ITEM 4. DEVELOPMENT APPLICATION: 810-822 ELIZABETH STREET WATERLOO**FILE NO: D/2013/700****DEVELOPMENT APPLICATION NO: D/2013/700****SUMMARY****Date of Submission:** 29 May 2013**Additional information** 19 and 30 July 2013 and 21, 23 and 28 October 2013**Applicant:** Icon Developments Australia Pty Ltd**Architect:** MPRDG**Developer:** Waterloo Landholdings Pty Ltd**Owner:** Waterloo Landholdings Pty Ltd**Cost of Works:** \$50,281,582**Proposal Summary:** The subject application seeks consent for a mixed use development, ranging in height from 4 to 7 storeys, and encompasses the following:

Figure 16: North-South section of Buildings A and B illustrating the location of existing ground level on site and the technical breach to the building height development standard

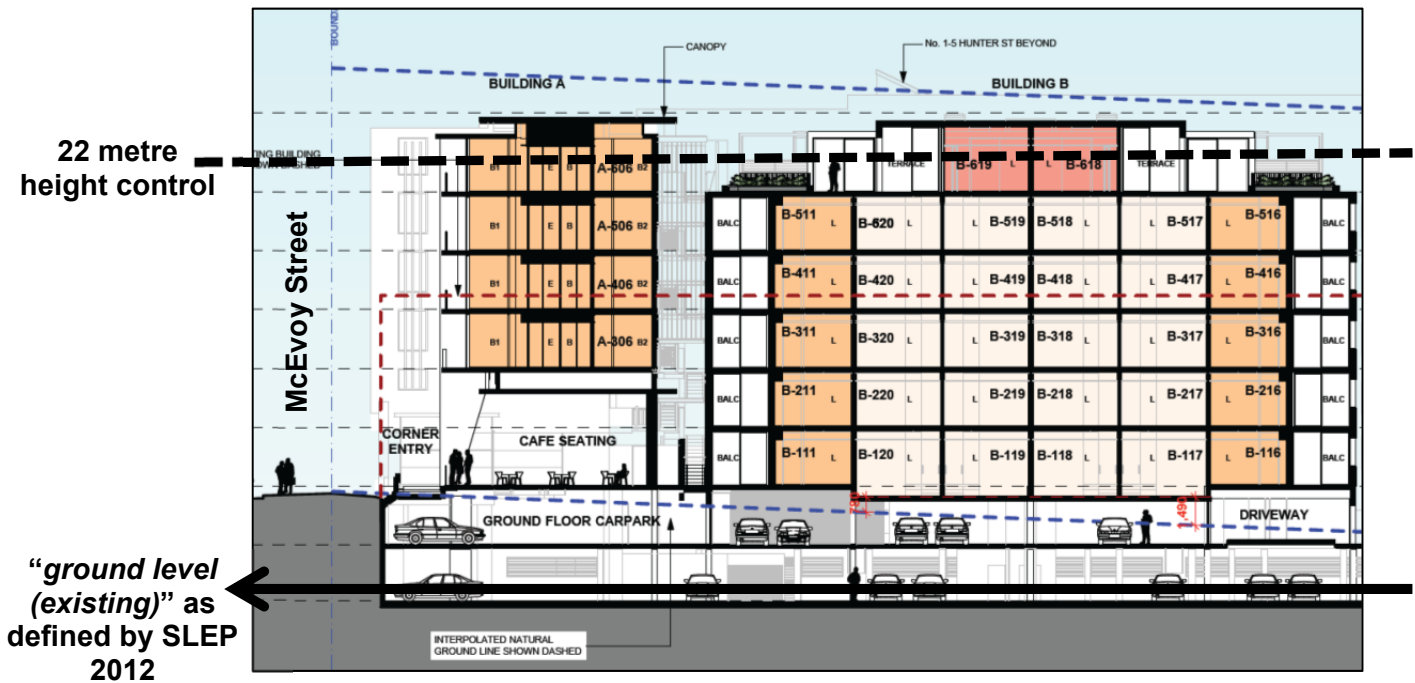
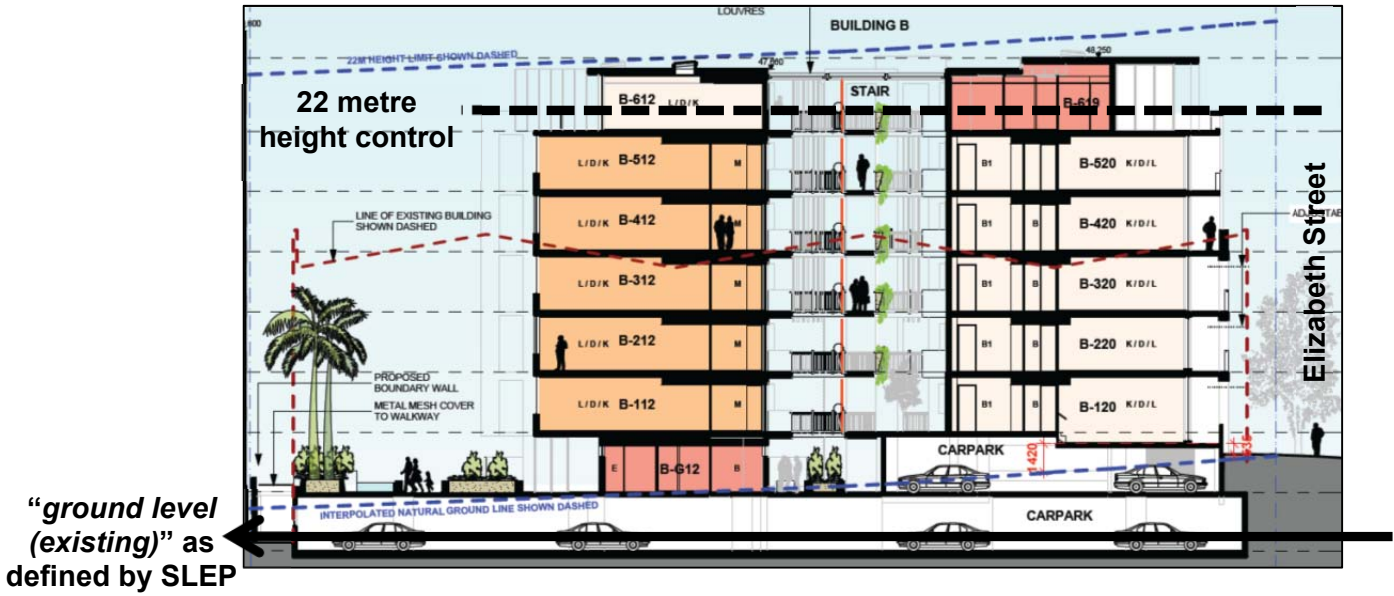
64. The proposal results in a breach to the 22 metre height development standard by 2.7 metres or a 12 % variation.
65. The applicant is relying on the provisions of Clause 4.6 of SLEP 2012 seeking to vary the height development standard by a maximum of 2.7 metres. Clause 4.6 allows Council to vary development standards in certain circumstances and provides an appropriate degree of flexibility to achieve better design outcomes. The Council may grant the exception pursuant to the Director-General’s general concurrence granted on May 2009 to cover Clause 4.6(4)(b) of SLEP 2012.
66. In order to demonstrate that the strict numeric compliance is unreasonable and unnecessary in this instance, pursuant to the provisions of Clause 4.6, the proposed non-compliance has been considered against the objectives of the height development standard in the following table.

Figure 18: The location of ground floor apartments on the Elizabeth Street (western elevation) frontage of the site that are capable of accommodating an individual entry.

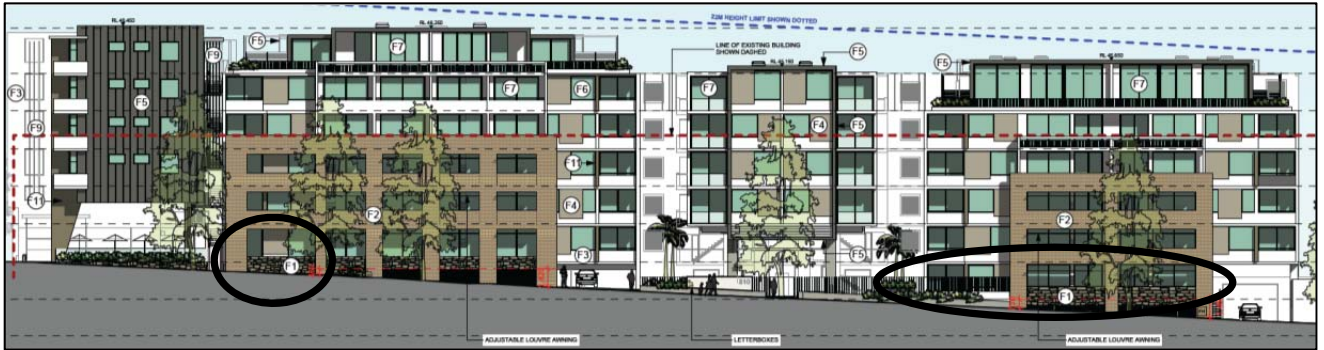
- (a) provision of individual entries to the following residential apartments that front Elizabeth Street (Apartments D-G31, D-G37, D-G38 and B-111) in order to provide greater activation to the streetscape (refer to **Figure 18**, below);

- (b) further resolution of the treatment of the ventilation louvres on the northern elevation of Building A and western elevations of Buildings B and D that service the car parking levels. In their current form, these louvres are proposed to a height of 1.4 metres above footpath level (refer to **Figure 19**, below). Consideration should be given to selection of materials and colours to ensure an appropriate blending with the podium treatment of the development, and the use of landscaping screening to minimise the visual impact of these service louvres on the facade;

- (a) Amended plans shall be submitted to provide individual entries from the Elizabeth Street frontage of the site to ground floor level apartments in Building D numbered D-G31, D-G37 and D-G38 and Level 1 apartment in Building B numbered B-111.

- (b) Amended plans shall be submitted to further refine the materials, colour scheme and use of landscape screening of the car park ventilation louvres located on the northern elevation of Building A and western elevations of Buildings B and D to minimise the visual impact of these service louvres on the facade.

Figure 20: The proposed atrium/internal walkways between buildings (for Buildings B and C), with external operable privacy louvres shown.

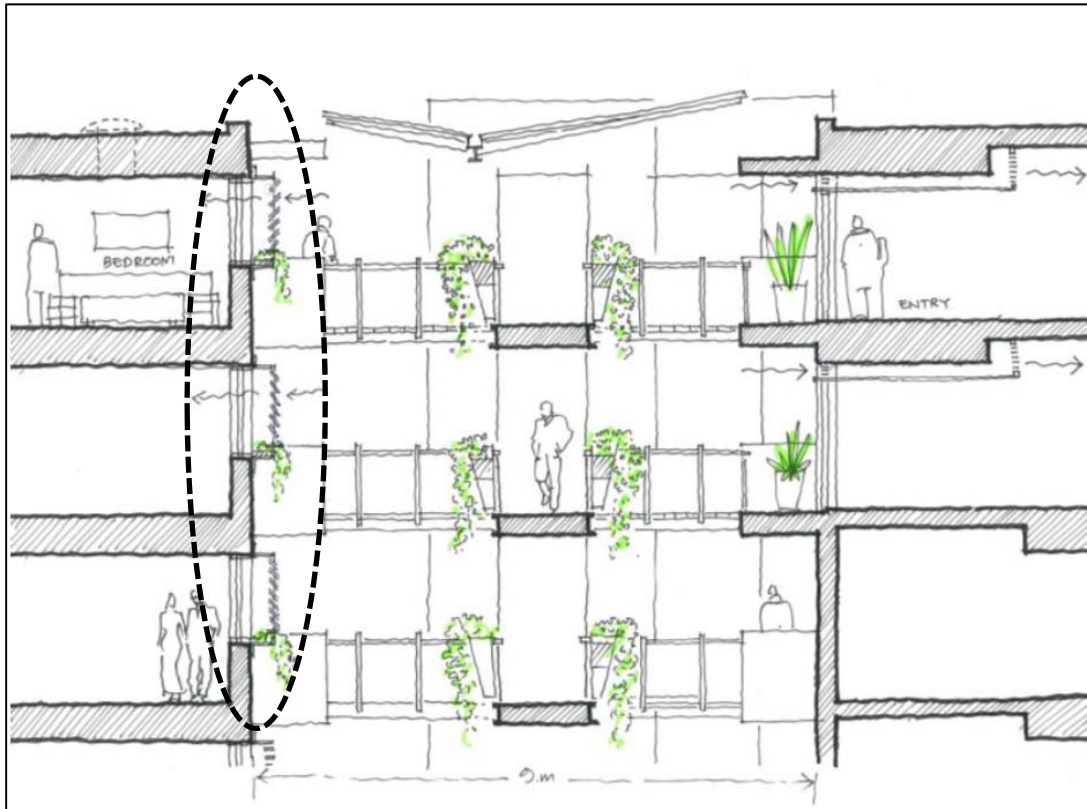
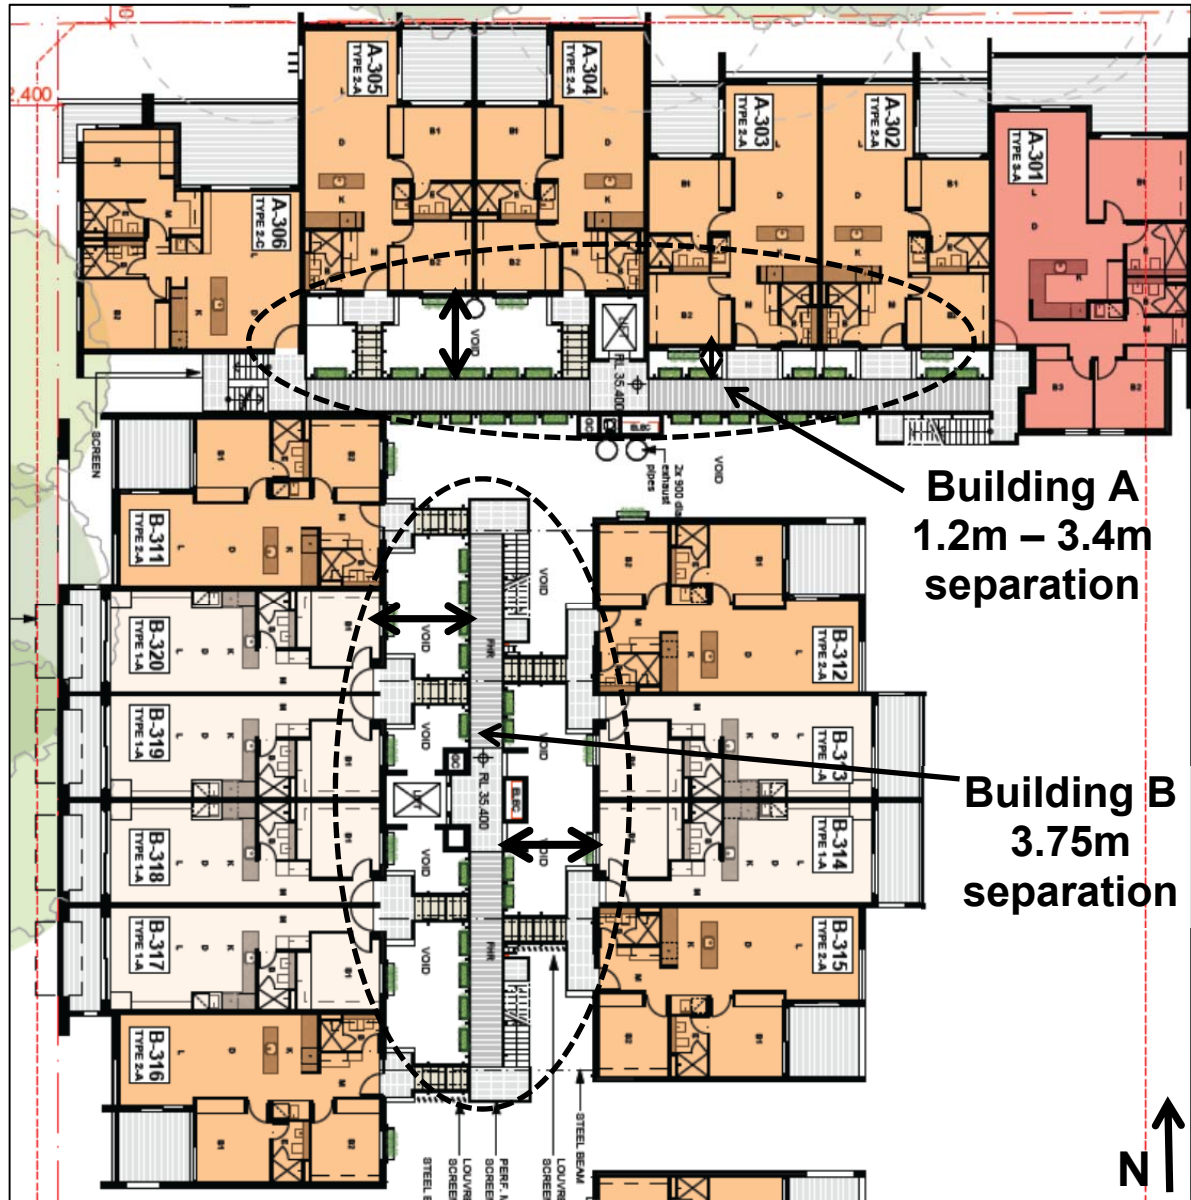
- 78. There has been significant design resolution to address potential overlooking from these walkways/bridges to internal facing windows of apartments. In its revised form there are elements where these walkways are separated from apartment windows by between 1.2 to 3.4 metres in Building A and approximately 3.75 metres in Buildings B and C. **Figures 20** and **21**, below, illustrates the use of offset windows, external operable privacy louvres, strategically placed lift cores/services and feature planting to minimise direct overlooking.

79. Whilst it is considered that sufficient screening and design mechanisms have been incorporated into the proposal to prevent direct overlooking into bedroom windows from these walkways, it is still considered that there is scope for potential acoustic privacy impacts to arise. It is recommended that a condition be imposed to require investigation of floor finishes along the internal walkways to minimise footfall noise transferring to surrounding apartments.

Figure 22: Separation distances between the balconies of the proposed development and the bedroom windows and balconies of the adjacent apartment building.

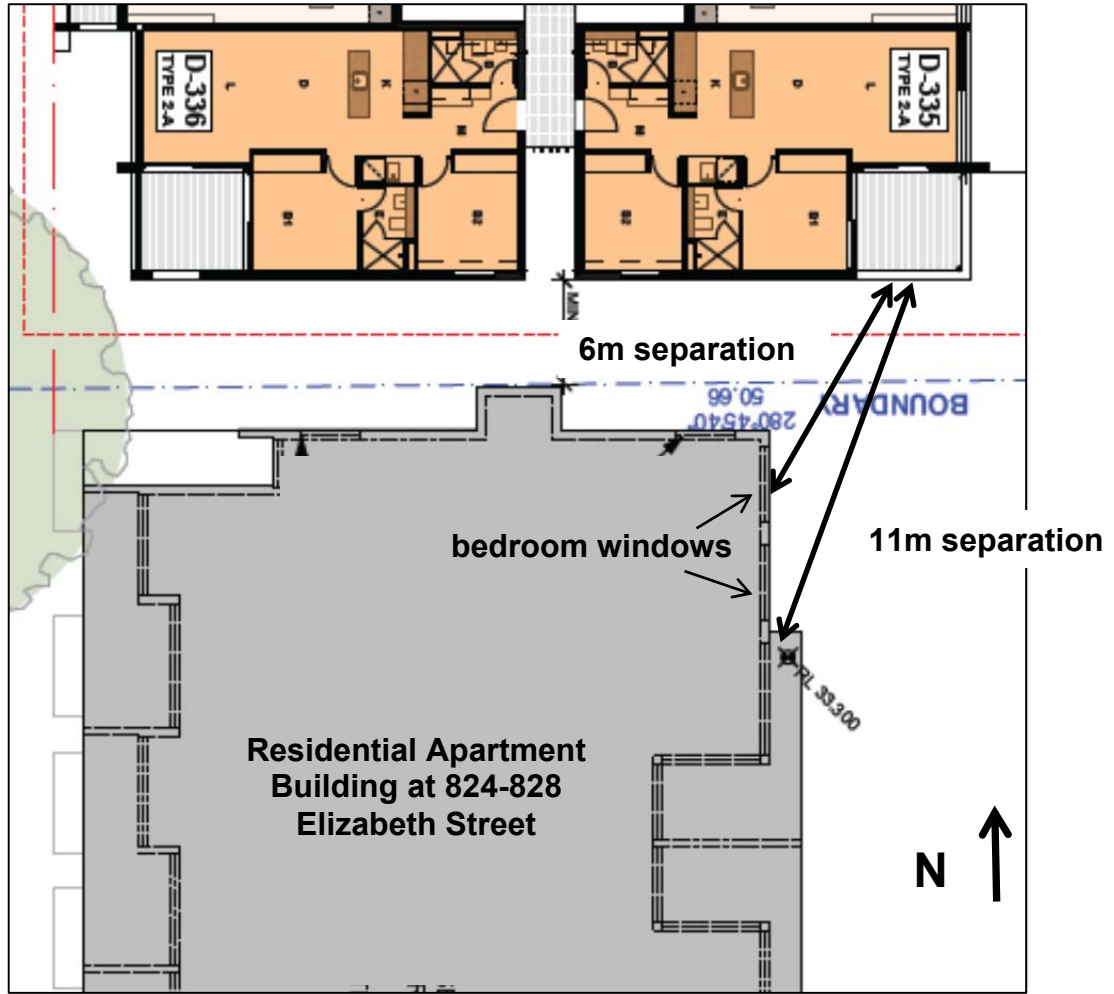
80. As detailed in **Figures 22** and **23**, below, opportunity exists for overlooking from the balconies of the apartments located in the southeastern corner on Levels 1 to 5 of the proposed development (being Apartments D-135 to D-535, inclusive). These proposed balconies are separated 6 metres from the bedroom windows of the adjacent apartment building to the south at 824-828 Elizabeth Street, where the Residential Flat Design Code recommends a separation of 12 metres between habitable rooms and balconies.
81. In this instance as the angle is oblique, it is considered that the separation distance is acceptable, subject to the introduction of some form of privacy screening along the southern elevation of these balconies. An appropriate design modification condition is recommended to this effect.

- (c) Amended floor plans and southern elevation plan shall be submitted to include the installation of privacy screening along the southern elevation of the balconies of apartments numbered D-135, D-235, D-335, D-435, D-535 in Building D. These screens shall be to a minimum height of 1.6 metres above the finished floor level of each balcony and shall be designed to prevent views from these balconies towards the eastern elevation windows and balconies of the adjacent apartment building at 824-828 Elizabeth Street.

Figure 24: Proposed on-site garbage collection area, including vehicle turntable, in the basement car park.

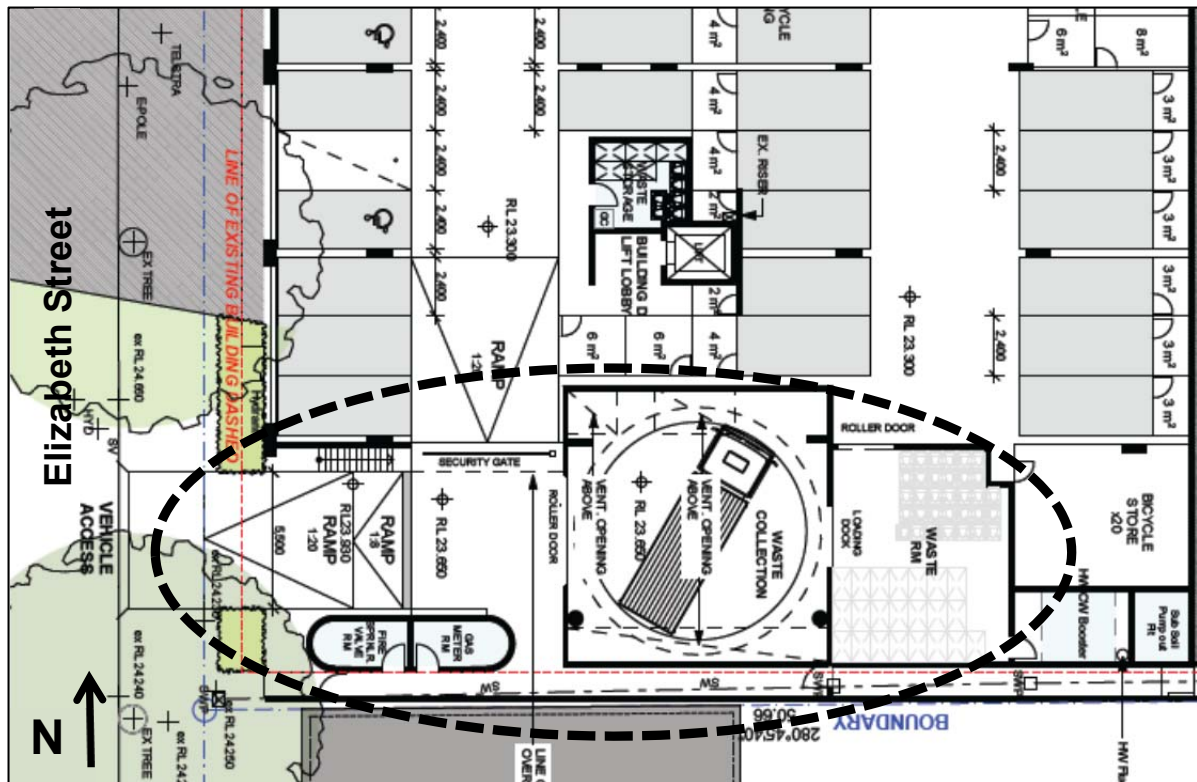
82. The proposed development includes a garbage storage and on-site waste collection area in the southwestern corner of the site. The waste collection area and turntable has been designed to accommodate an 8.8 metre long vehicle. **Figure 24**, below, illustrates the proposed garbage room configuration.

84. Whilst the provision of these facilities on-site is supported, further design refinement will be required to the basement configuration to allow for a larger vehicle turntable to be provided on site to allow standard waste collection vehicles to both access and manoeuvre on site. In order to achieve the requisite clearance and turntable of a sufficient length, reconfiguration and/or relocation of the 3 residential storage cages and one car parking space located directly to the north of the garbage collection area will be required.

An amended basement floor plan shall be submitted to illustrate a vehicle turntable with sufficient dimensions to accommodate a standard Council waste collection vehicle, with this plan to include any reconfiguration required to the basement layout in order to accommodate this revised garbage collection area.
